## TECHNICAL MEMORANDUM

**Re: Treatability/Pilot Study Modification No. 9  
Nevada Environmental Response Trust Site  
Henderson, Nevada  
Ramboll Project No. 1690011200-046**

**Treatability / Pilot Study  
Modification No. 9**

**Proposed Additional Well Locations**  
 Treatability/Pilot Study Modification No. 9 ZVI-Enhanced  
 Bioremediation Treatability Study

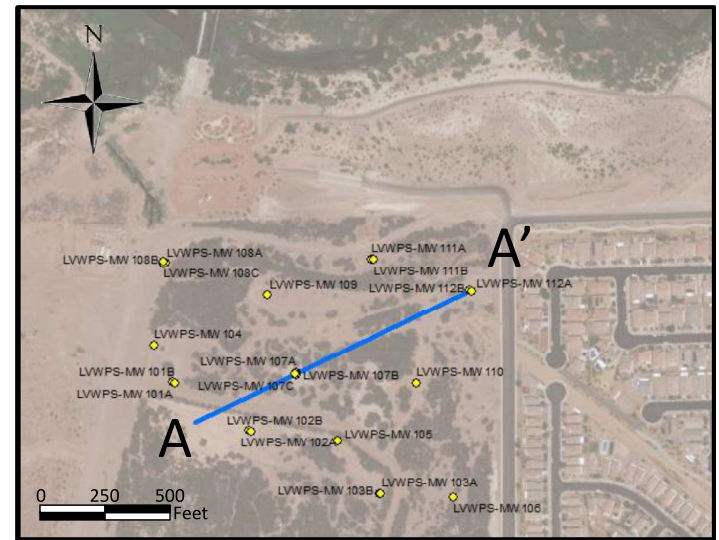
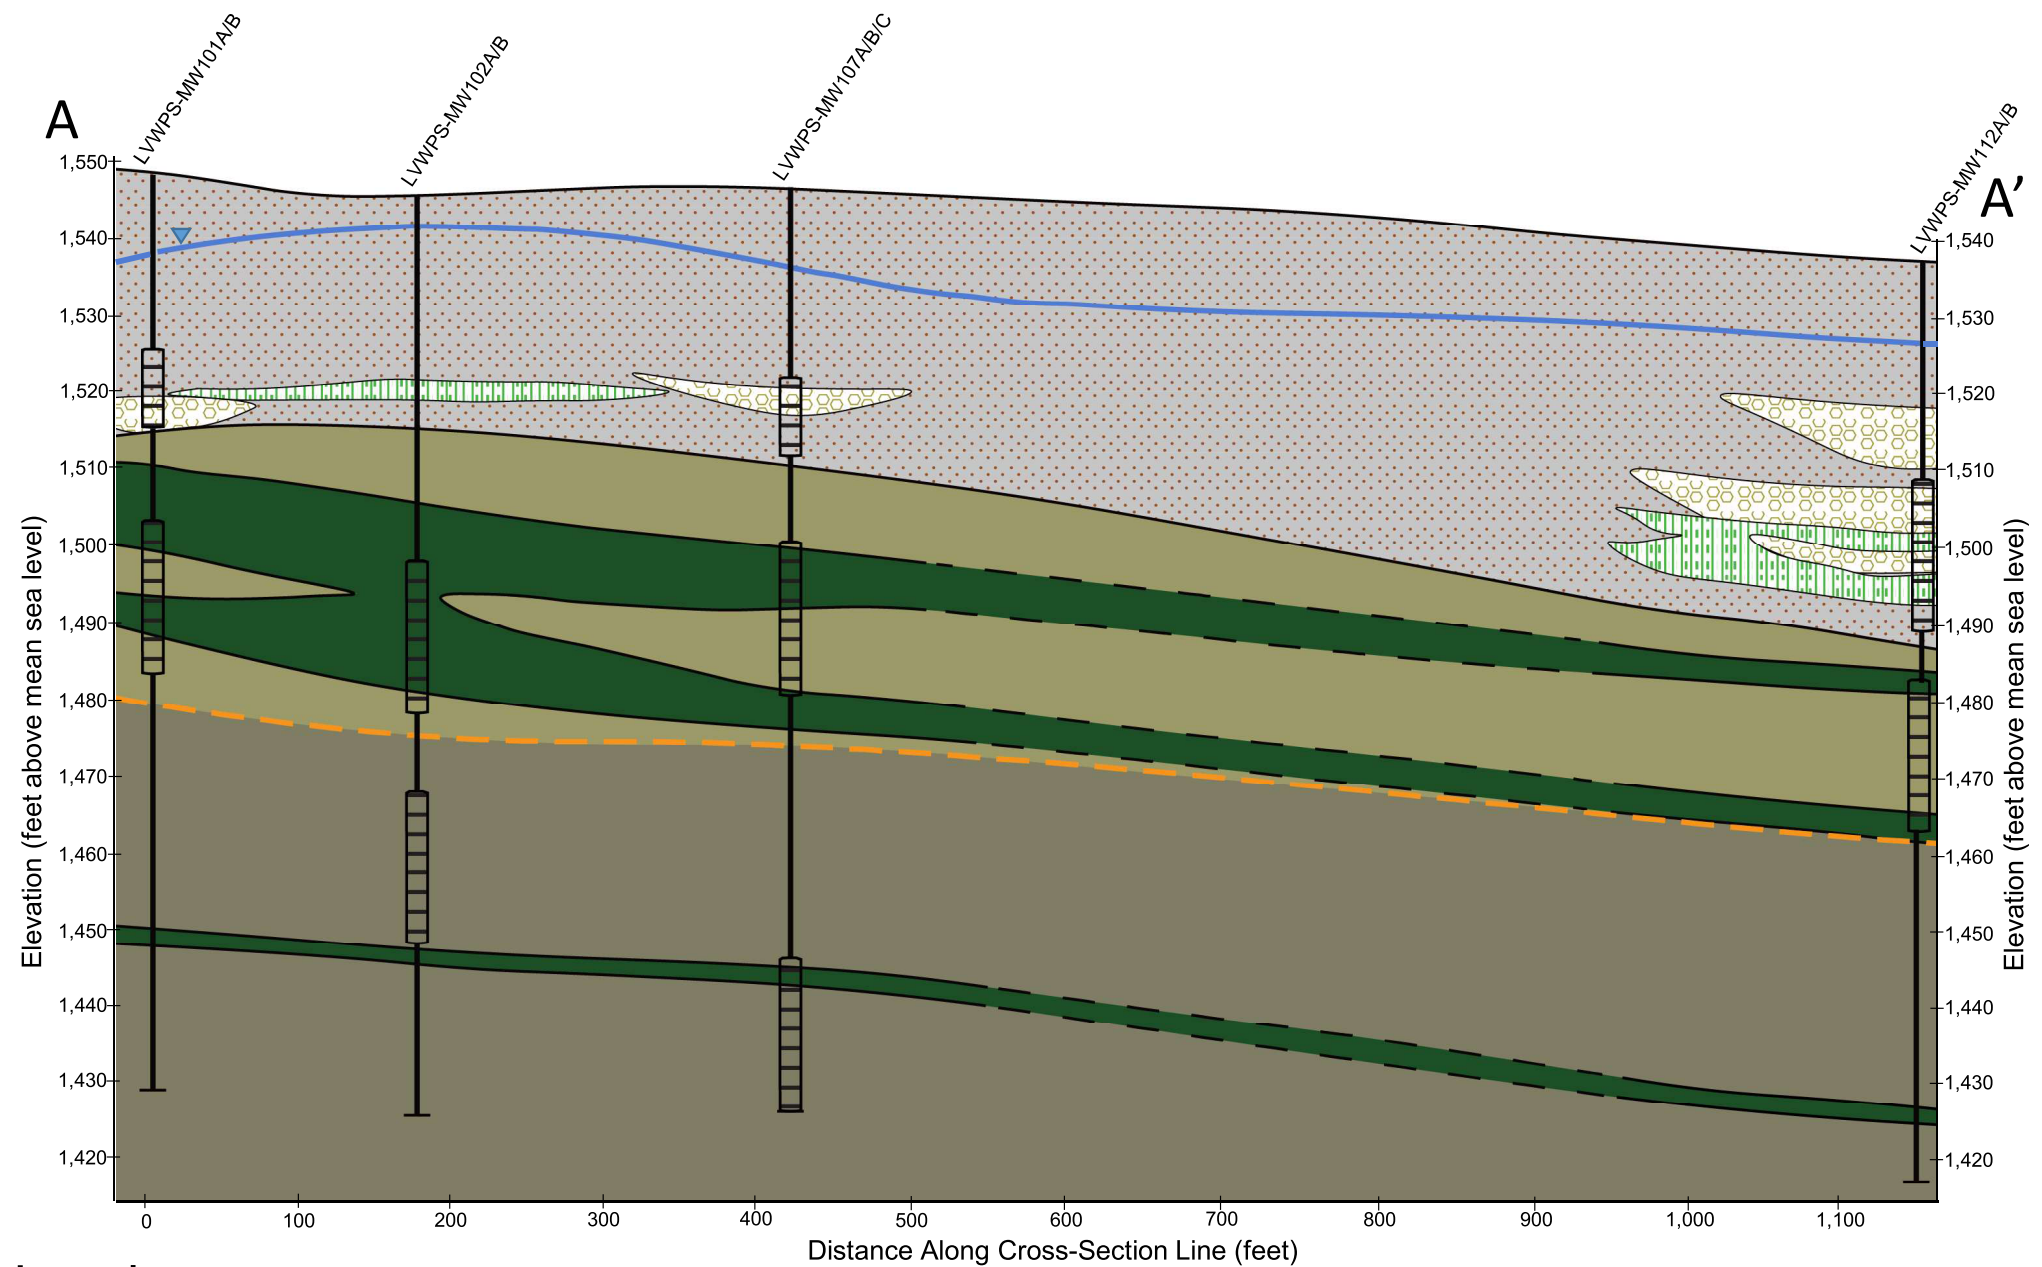
Three new four-inch diameter Schedule 40 PVC groundwater monitoring wells will be installed in the Transect 1A Study Area. Proposed locations are shown in Figure 2 and representative cross sections of the study area are presented in Figures 3 and 4. The new wells will be located adjacent to existing monitoring wells LVWPS-MW102A/B, LVWPS-MW104, and LVWPS-MW110, and installed with screened intervals of approximately 20 to 30, 50 to 70, and 20 to 30 ft bgs, respectively, as summarized in Table 1. Borings will be advanced to approximately 10 feet below the proposed depths listed above, and actual screen intervals may differ based on evaluation of lithology at the time of drilling. The proposed locations will allow for collecting additional cross-sectional information along alignments that are parallel and perpendicular to flow directions and thus will be critical for engineering the field pilot system.
